REMARKS

In Re: Application of: Winter, T.
Deep-Ribbed, Load-Bearing, Prefabricated
Insulative Panel and Method for Joining

Dkt. No. WR-151-BIGW

1/5

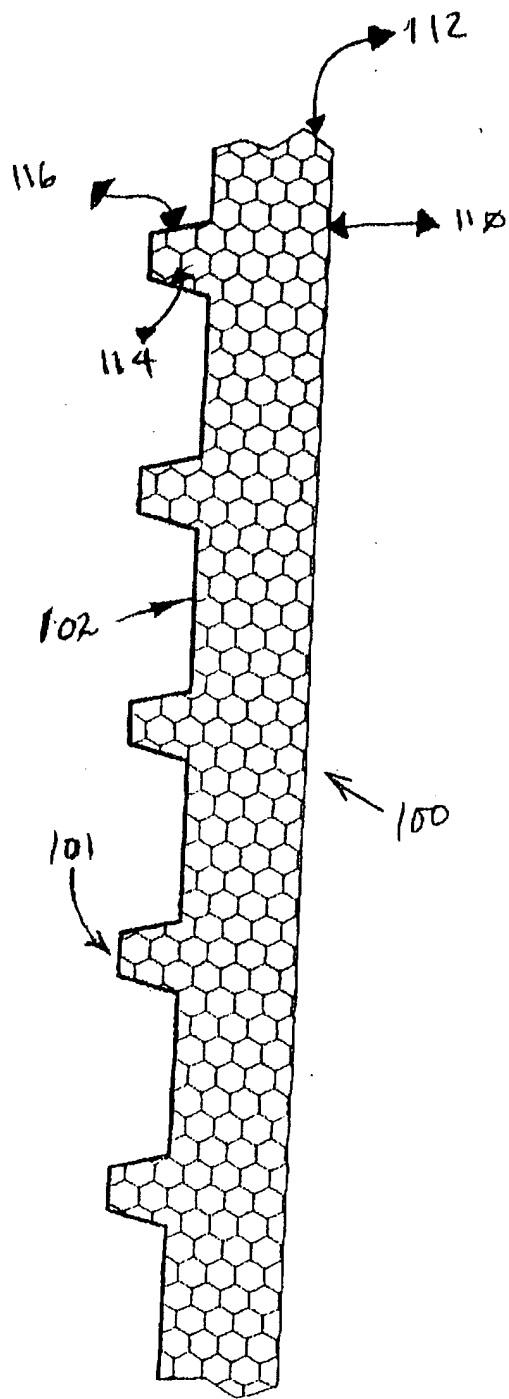
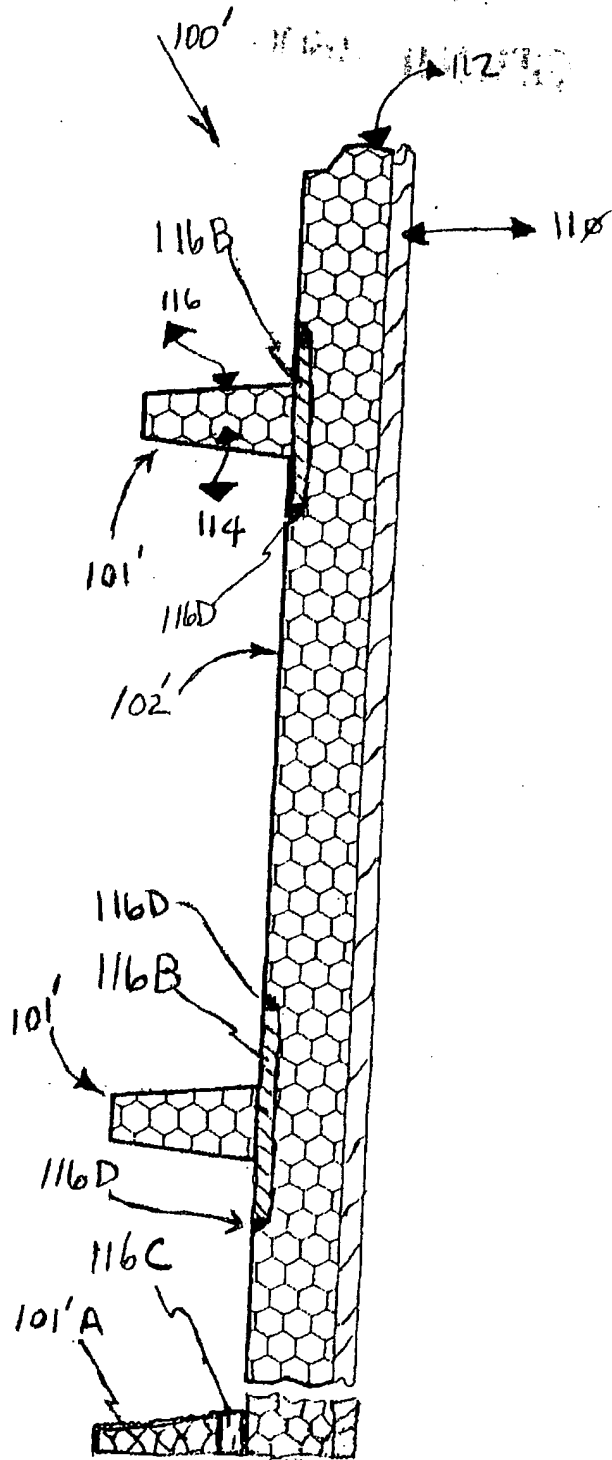
The drawings have been amended to overcome the rejections. With respect to the objections to Figures 1 and 1A, a replacement drawing sheet 1/5 is included herewith, to remove the text from Figure 1 and to darken some of the component numbers to make them more easy to read. Therefore, Applicant respectfully requests withdrawal of this objection and acceptance of the replacement drawing sheet. No new matter has been added.
